Supplement to April 21, 2025 MPWMD Board Packet

RE: Recent Seaside Basin Groundwater Model Results

SUBJECT: SEASIDE SUBBASIN GROUNDWATER DIVIDE

Figure 1. Seaside Basin Watershed and Storage Units as Drawn by K.S. Muir (USGS, 1982) based on 1979 water level data.

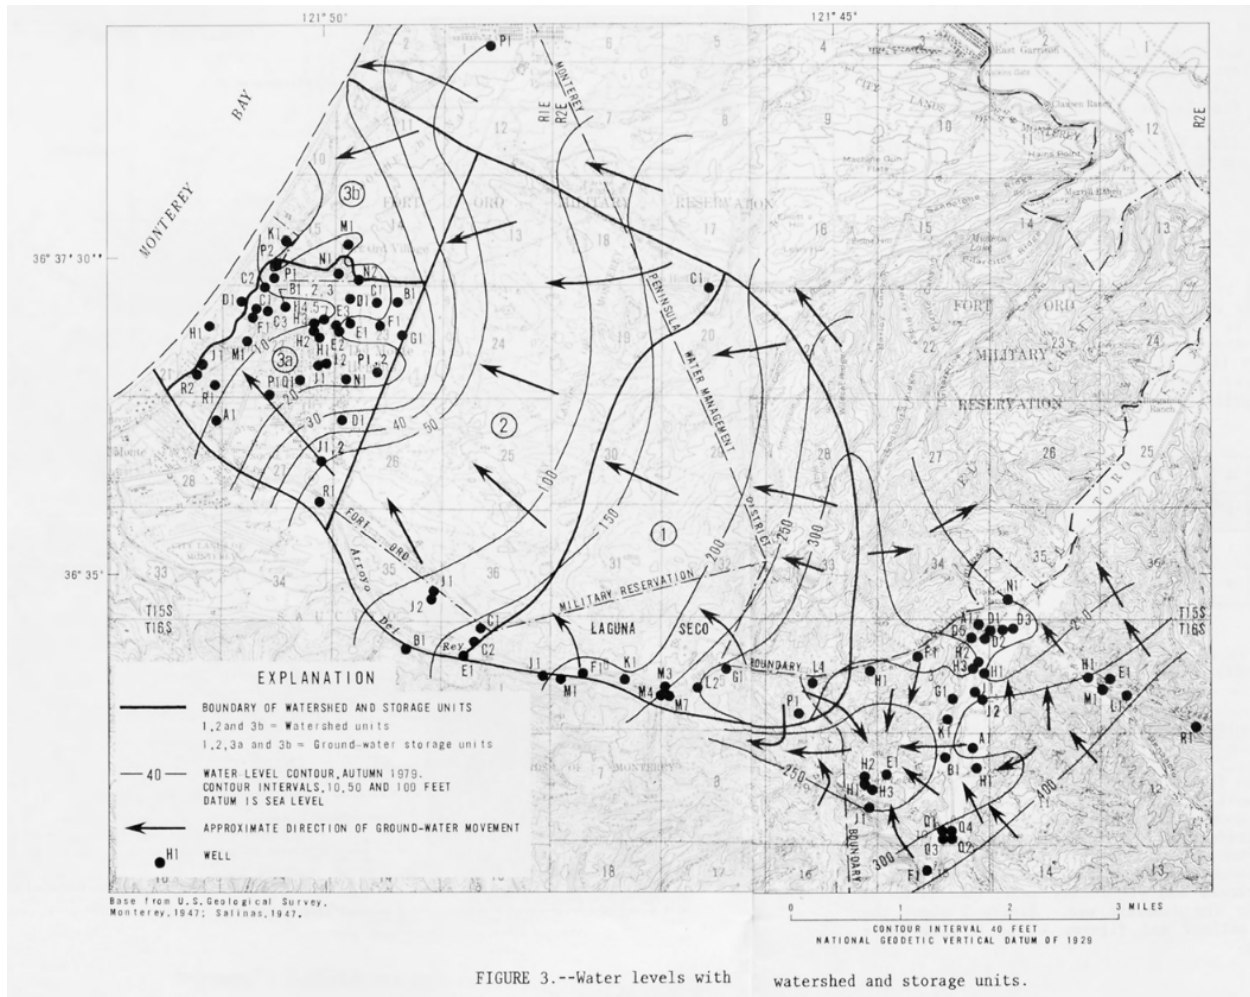
K.S. Muir (U.S. Geological Survey [USGS], 1982) describes that the data were averaged from wells screened across multiple depths and aquifers, and thus represents a composite of both the Deep and Shallow Aquifer. The report describes the north and east boundaries of the basin “watershed” as being “in the vicinity of groundwater divides”, but the northern boundary appears to be drawn slightly south of where an inferred flow divide would be located based on the drawn contour lines. It should be noted that there is only a single data point north of the boundary line with which to infer the position of a groundwater divide. The USGS 1982 report is cited as the basis for the basin adjudication boundary and for the DWR Bulletin 118 Subbasin boundary adopted in 2018.

Figure 2. Positions of Shallow (orange dashed line) and Deep Aquifer Flow Divide (blue dashed line)

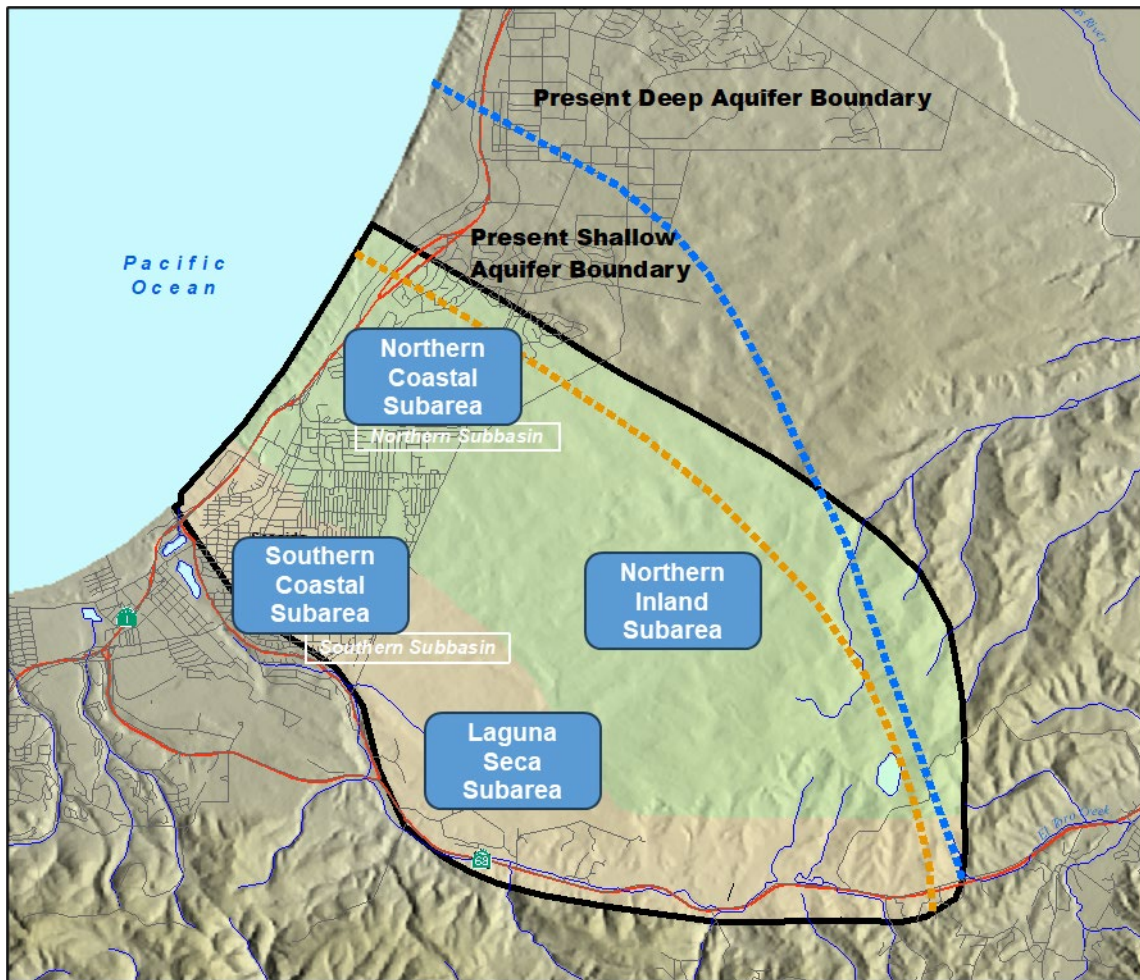
- The positions of the flow divides in the Paso Robles (PR) and Santa Margarita (SM) Aquifers are different (see Figure 2).
- The simulated and mapped position of the flow divides do not align with either the Adjudicated or the DWR Bulletin 118 jurisdictional Basin boundaries (see example on Figure 3).

These flow divide positions are based on hand drawn contour maps of water level data from fall 2002 by Yates *et al.* (2005), as shown in a slide presentation of the 2009 Basin Management Action Plan (BMAP) (HydroMetrics, LLC, 2009a).

Figure 3. Plot Showing Simulated Position (yellow area) of Ground Water Divide in the Deep Aquifer

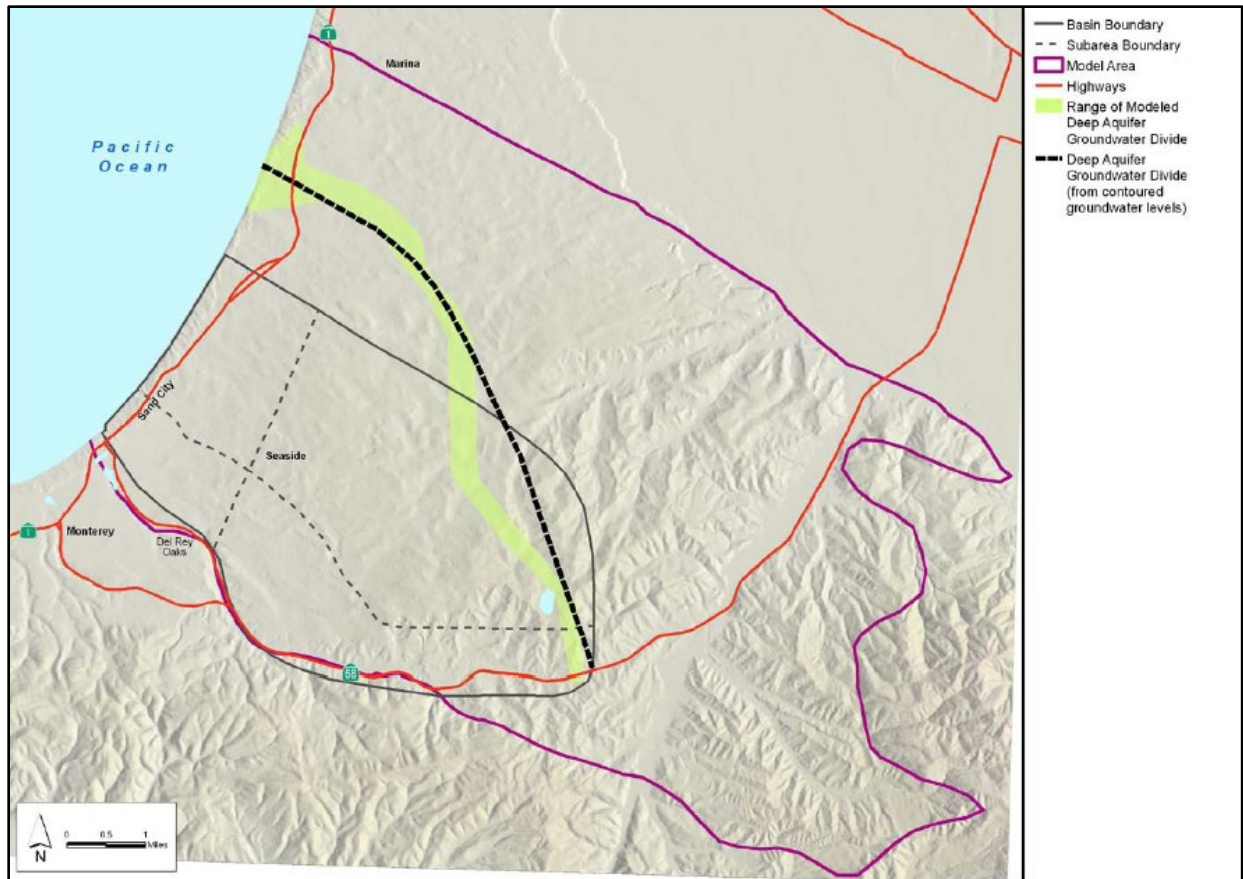
This figure was presented in the 2009 modeling report (HydroMetrics LLC, 2009b). Note that the simulated position of the Deep Aquifer groundwater divide differs significantly from the jurisdictional boundary line (thin black line) and has differences with the Deep Aquifer divide as mapped by Yates *et al.* (2005) from hand contoured 2002 groundwater level data (thick dashed line). The 2009 modeling report did not show or discuss how the simulated Shallow Aquifer groundwater divide compared with the jurisdictional boundary or the Yates *et al.*, Shallow Aquifer boundary, but a brief review of modeling results shows that while similar in a broad sense, they also differ in many places. This suggests that the hand drawn flow divides based on limited water level data sets are simplified representations of more complex and dynamic boundaries.
